Access Compliance Report

Public Rights-of-Way

(Curb Ramps)

Intersection ID: 2675	Main Street: HEATHCREST_CT	Cross Street: MCCHESENEY_DR	Location: E
ADA ID: 2868D15368F7	Ramp Type: PerpDiag	Initial Pass/Fail: Fail	Overall Compliance: No
		Severity Score: 12.5

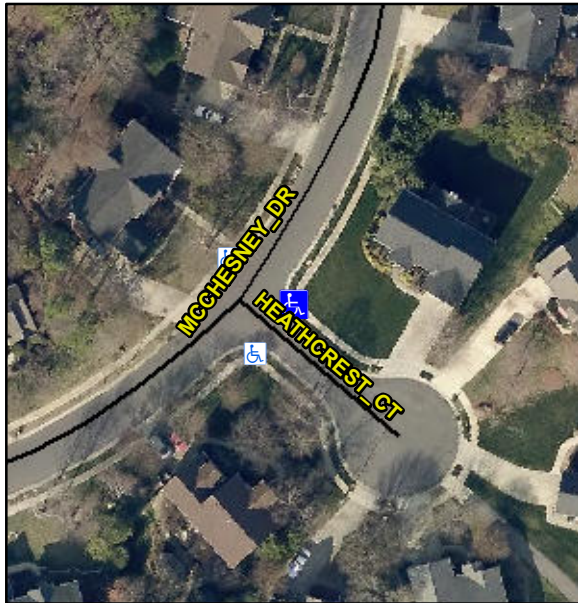
Not Found, R304.5.3

Compliance	Description	Data	Compliance	Description	Data
N/A	Ramp Length (in)	50.0	Yes	Ramp Slope (%)	6.5
Yes	Ramp Width (in)	61.0	No	Ramp XSlope (%)	5.1
N/A	Flare Type LT	N/A	N/A	Flare Type RT	N/A
N/A	Flare Slope LT (%)	N/A	N/A	Flare Slope RT (%)	N/A
N/A	Flare Traversable LT?	N/A	N/A	Flare Traversable RT?	N/A
N/A	Landing Length (in)	N/A	N/A	DWS Provided?	N/A
N/A	Landing Width (in)	N/A	N/A	DWS Contrast?	N/A
N/A	Landing Slope (%)	N/A	N/A	DWS Length (in)	N/A
N/A	Landing X Slope (%)	N/A	N/A	DWS Full Width?	N/A
N/A	Landing Curb? (Y/N)	N/A	N/A	DWS Offset (in)	N/A
N/A	Shared Landing?	N/A			
N/A	Gutter Ponding?	N/A	N/A	Gutter Slope (%)	N/A
N/A	Gutter Lip Ht (in)	N/A	N/A	Gutter X Slope (%)	N/A
N/A	Painted X Walk1?	No	N/A	Painted X Walk2?	No
	X Walk 1 Direction	To SW		X Walk 2 Direction	To NW
N/A	X Walk 1 Width (in)	N/A	N/A	X Walk 2 Width (in)	N/A
	X Walk 1 Slope (%)	3.0		X Walk 2 Slope (%)	3.0
	X Walk 1 X Slope (%)	4.8		X Walk 2 X Slope (%)	1.6

Remove & Replace Curb Ramp With Two New Directional Ramps or Equivalent.
